CTC + AAC BP07 Core & Shell Group 2

ADDENDUM #1

## Addendum #01

| Project | UK CTC BP-07 Core and Shell Group 2 | UK Project #       | 2563.0     |

SHEET NO.  
A200

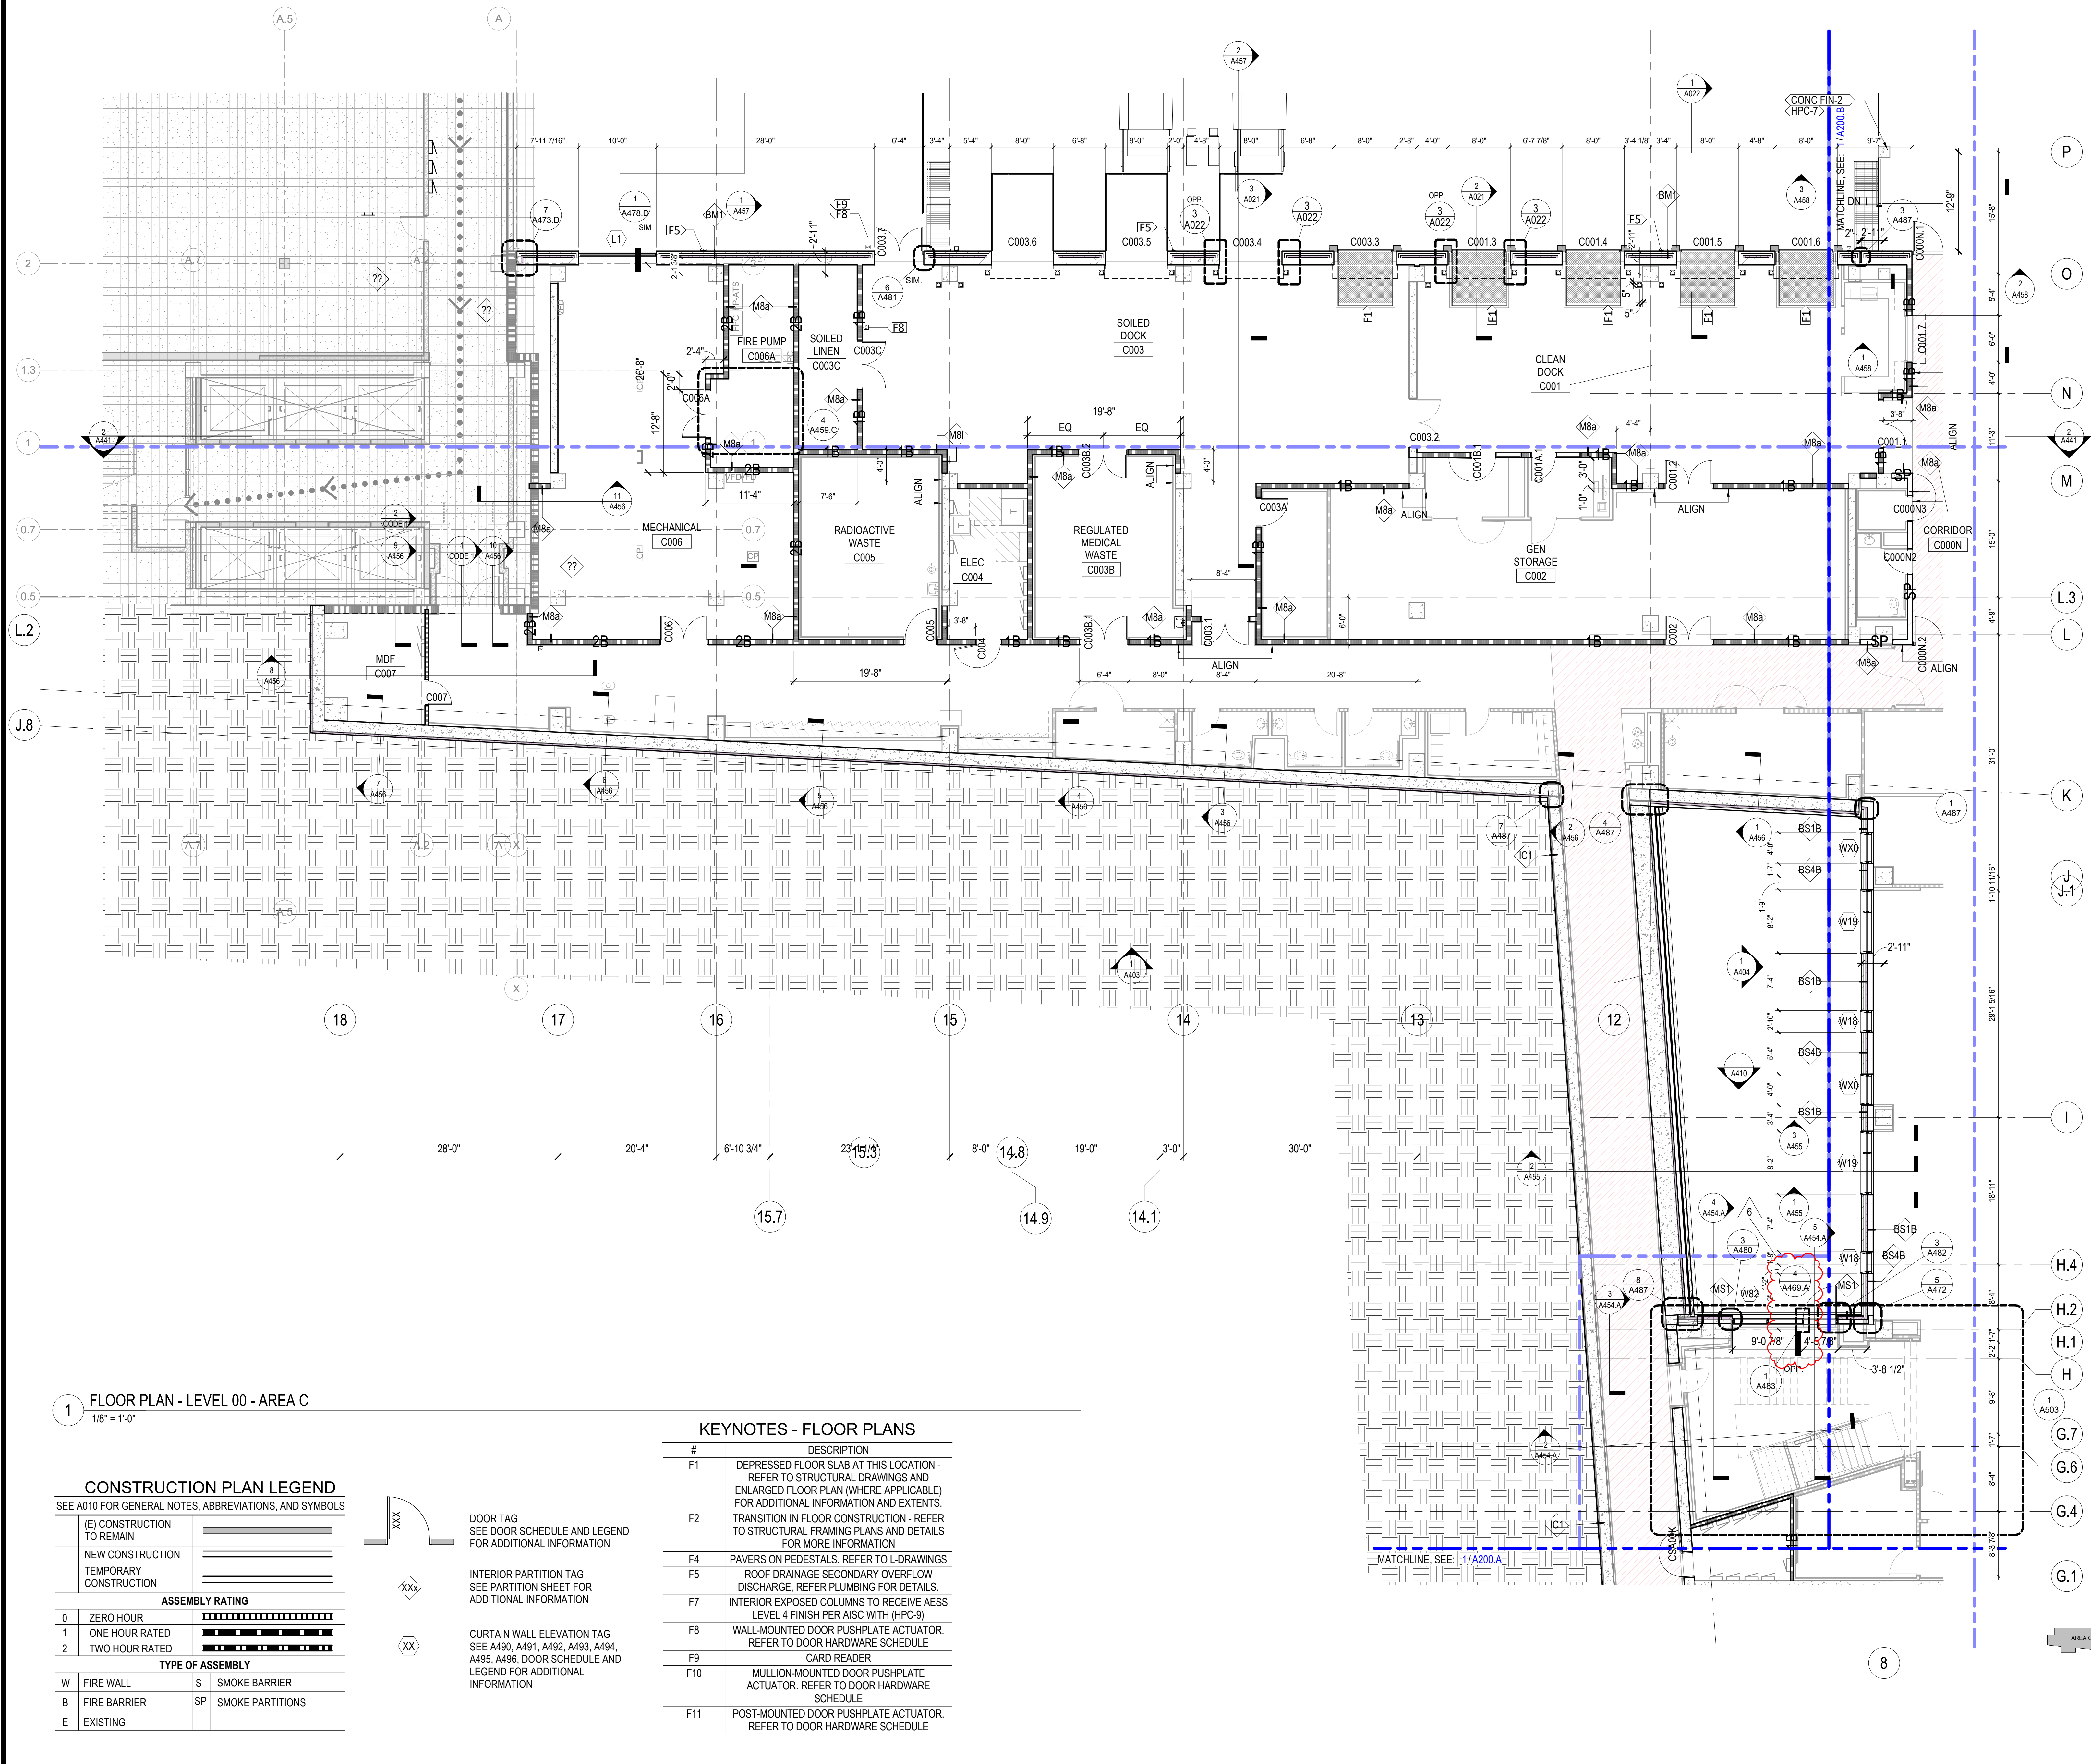
##### *A200 – OVERALL SHELL & CORE PLAN – LEVEL 00*

- Added material I.D. for LVR-1C*

**SHEET NO.**  
A200.C

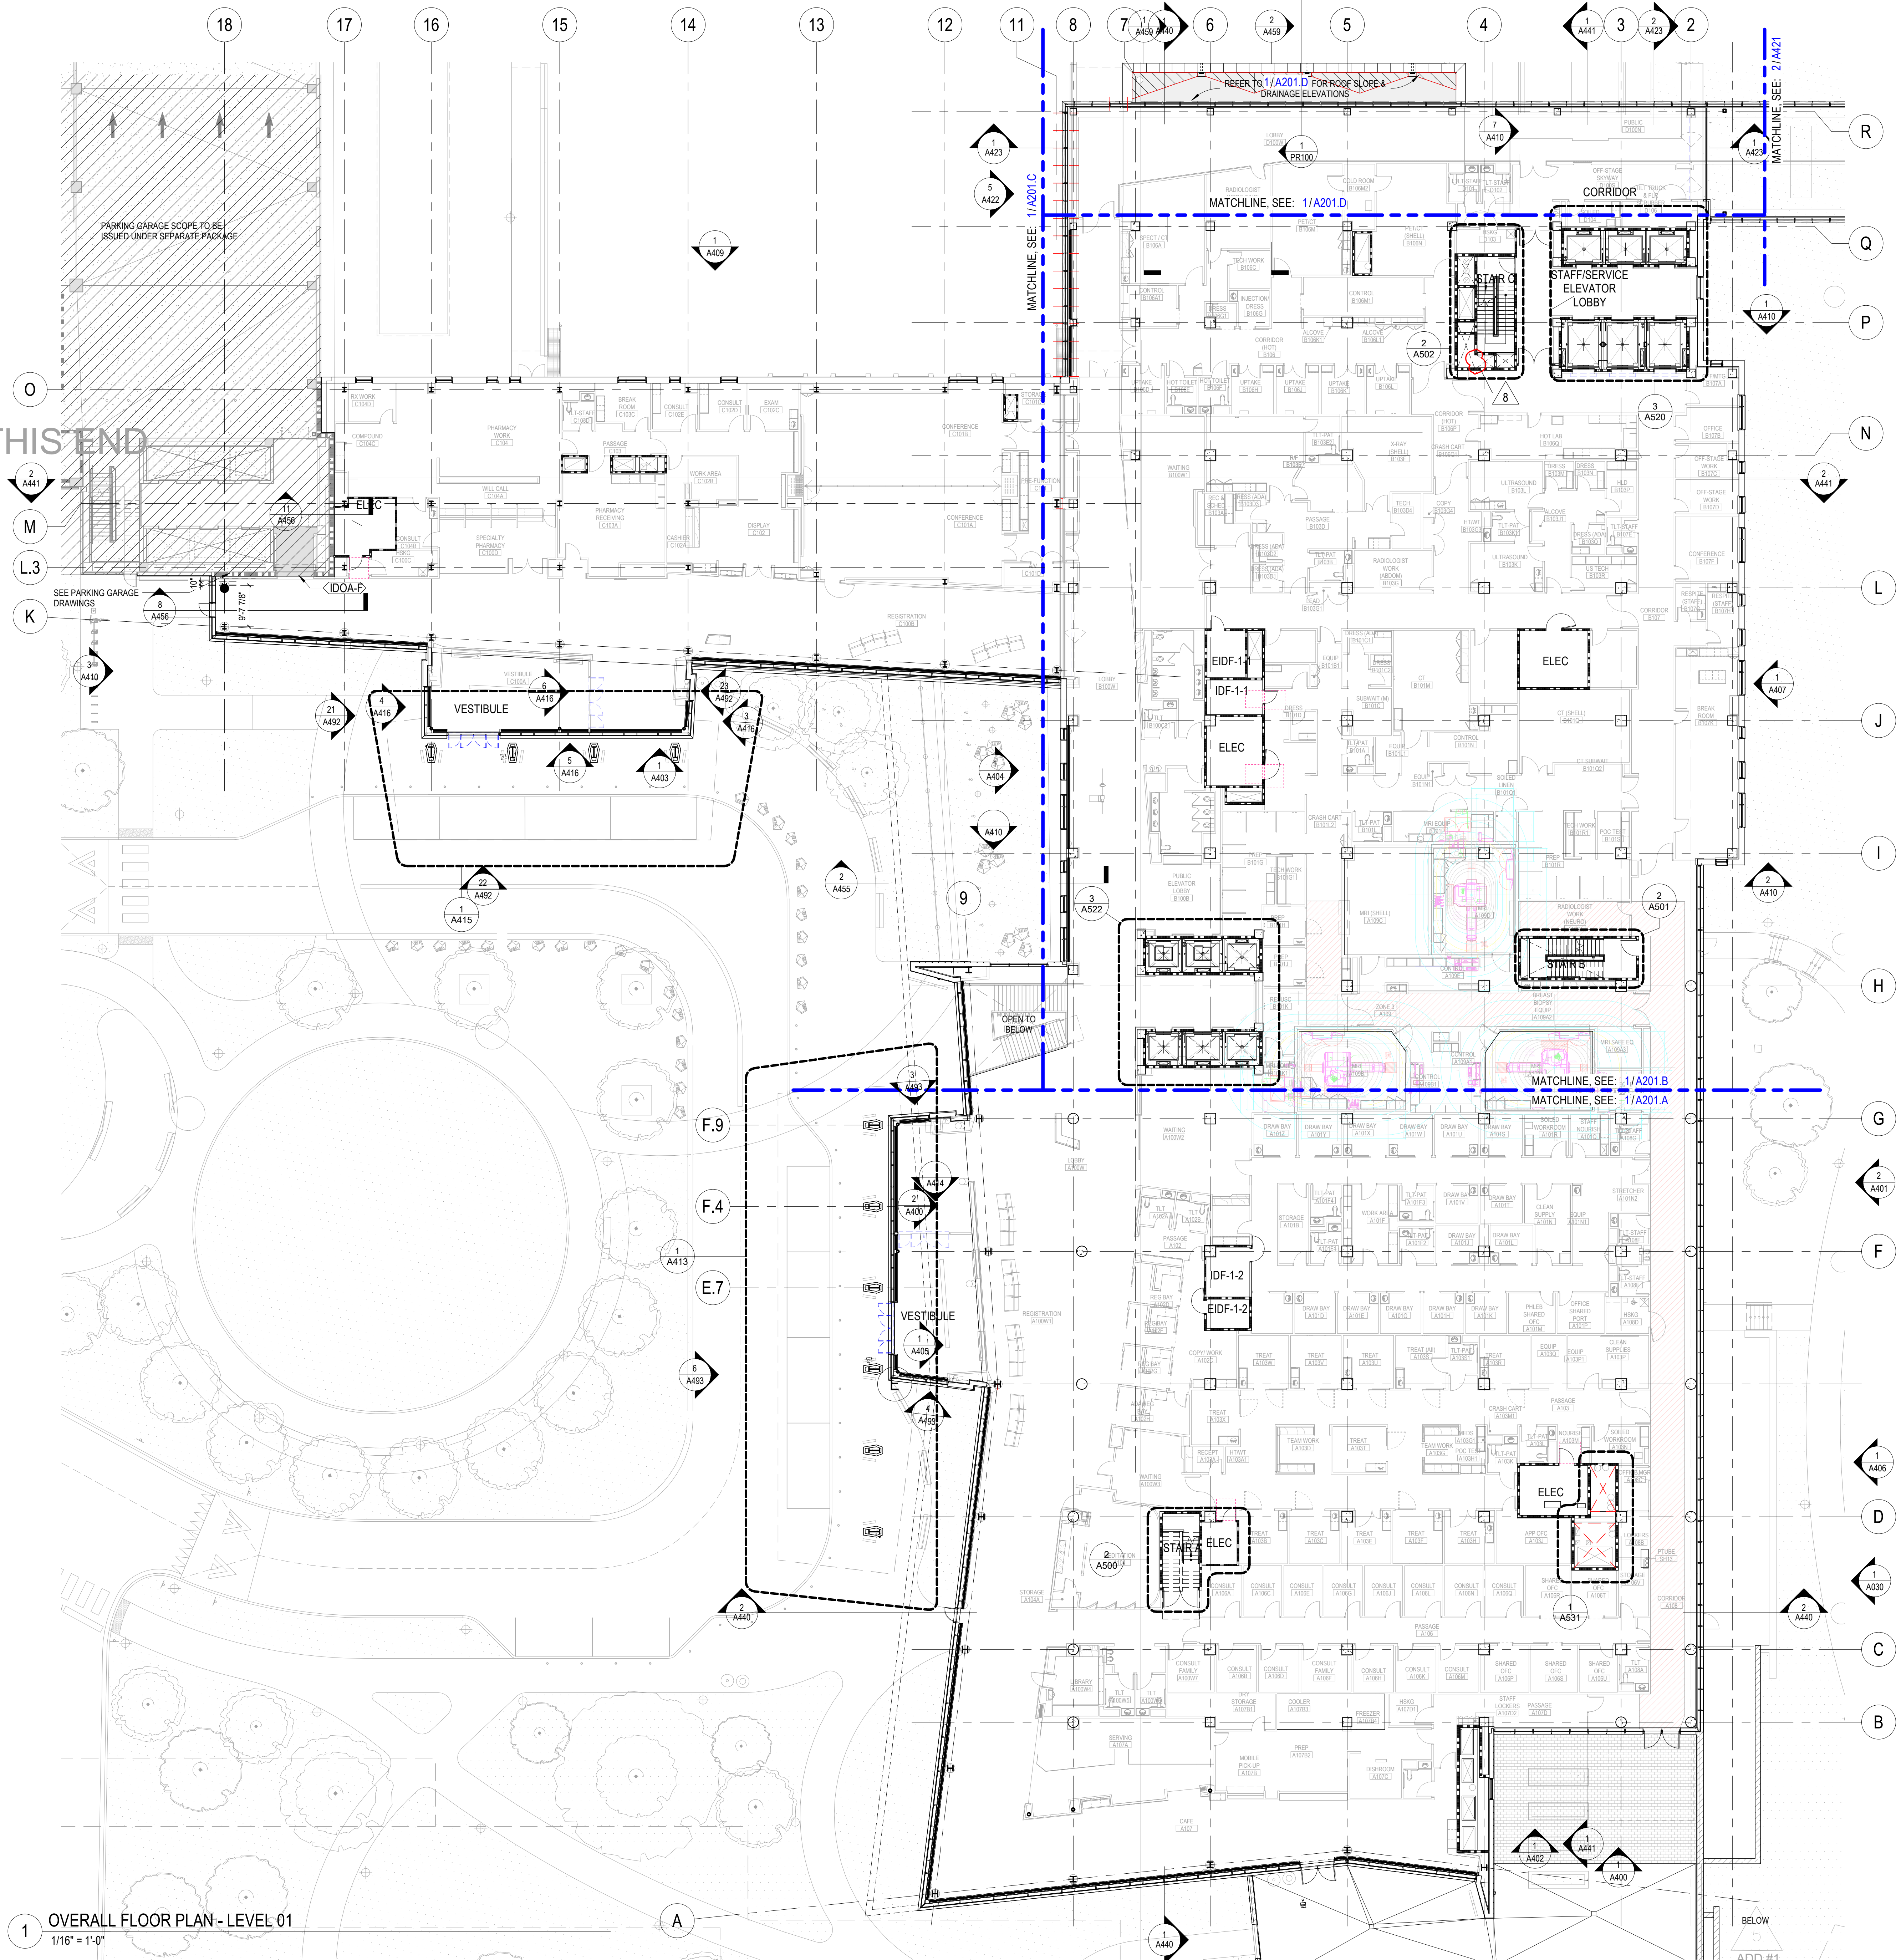
##### *A200.C - SHELL & CORE FLOOR PLAN - LEVEL 00 - AREA C*

- Added detail tag 4/A469. A.*

#### 4 WALL TYPE - BF 3" = 1'-0"

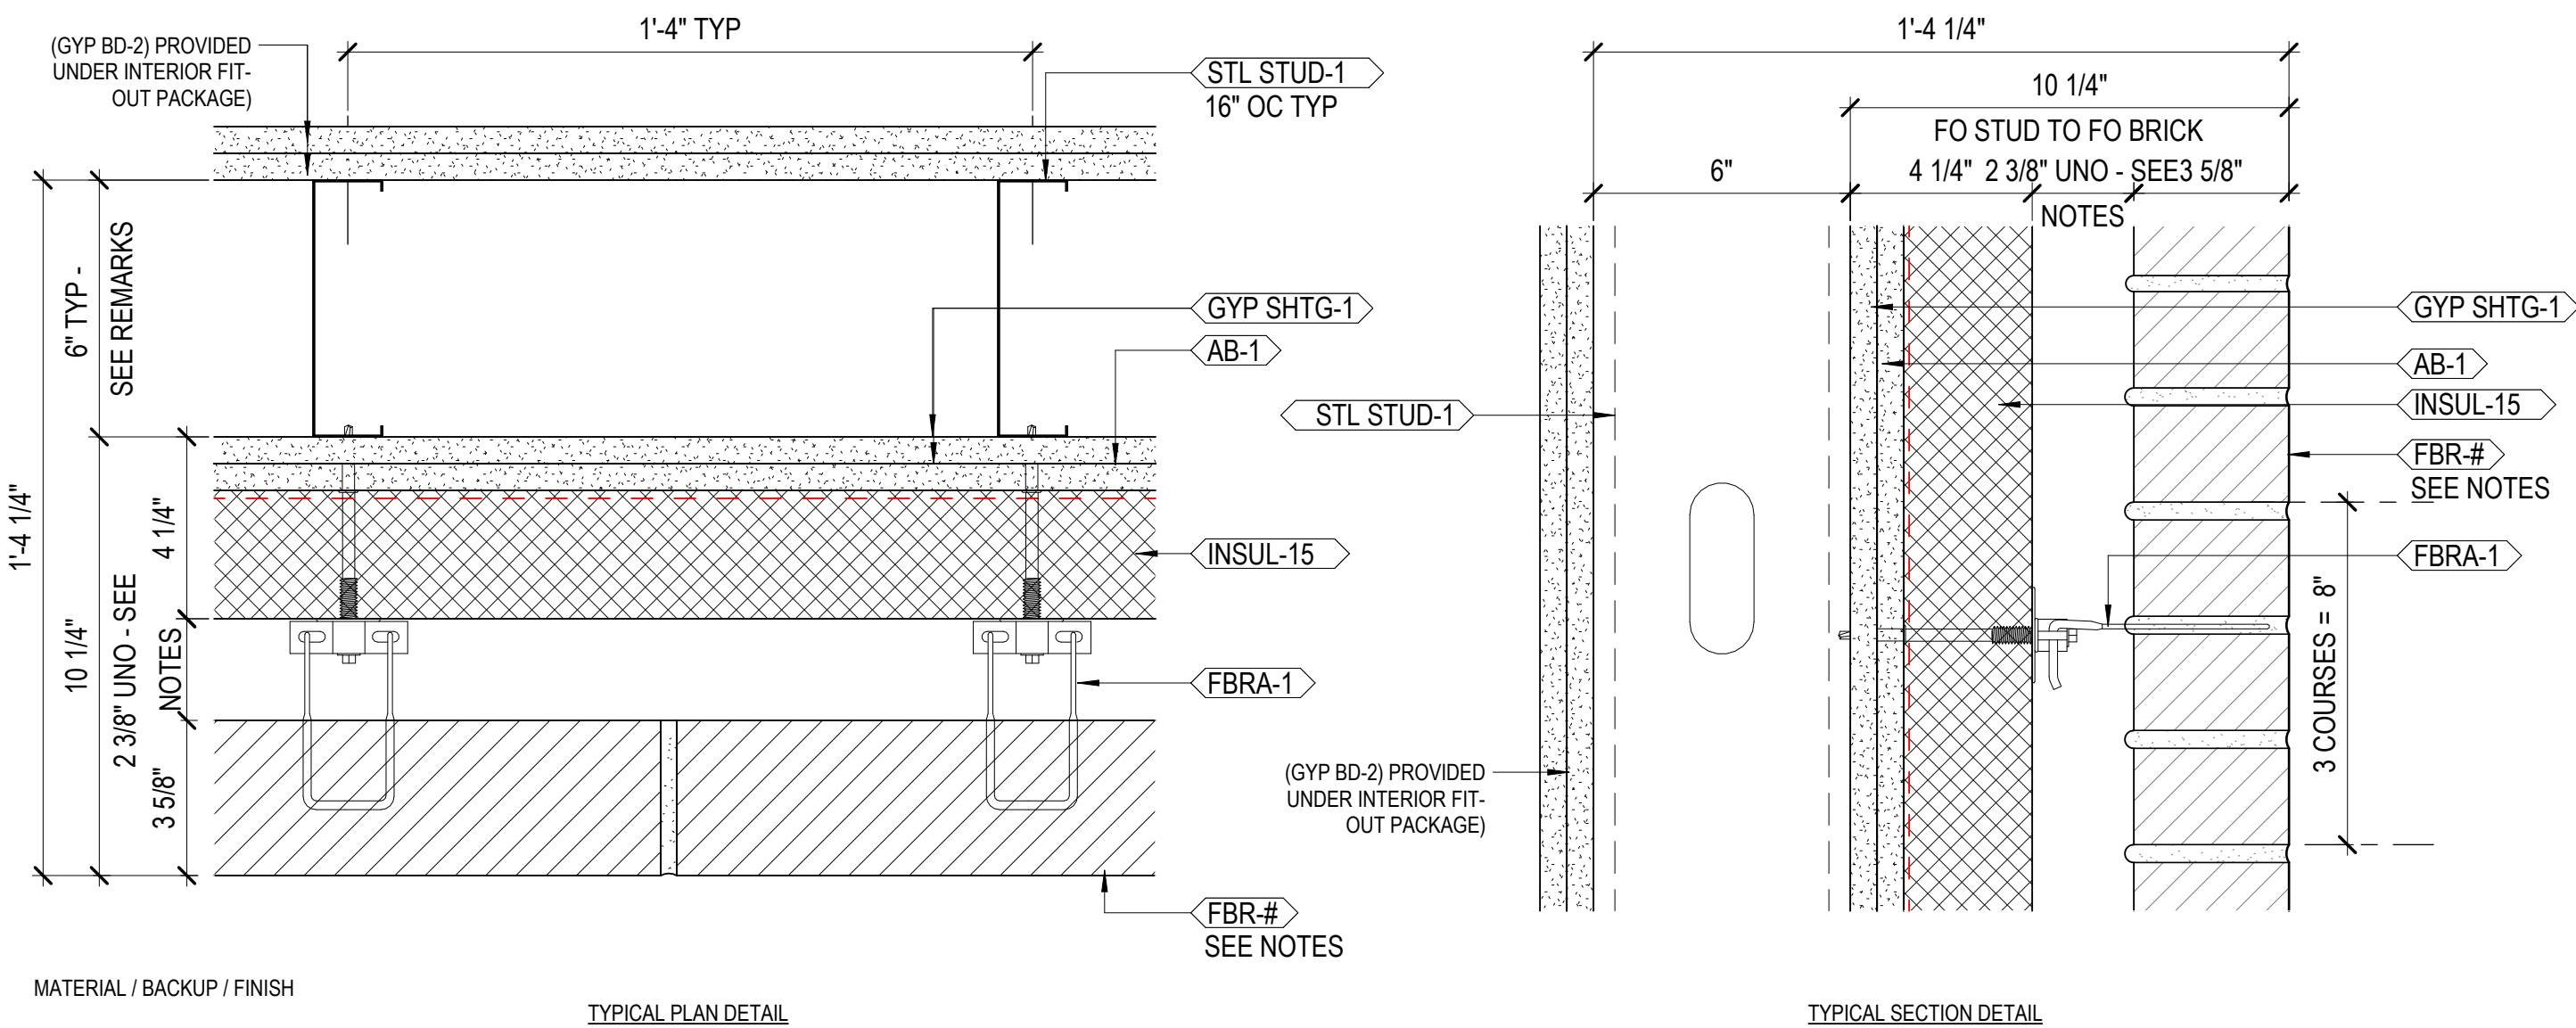
1. Add new exterior wall assembly, BF.
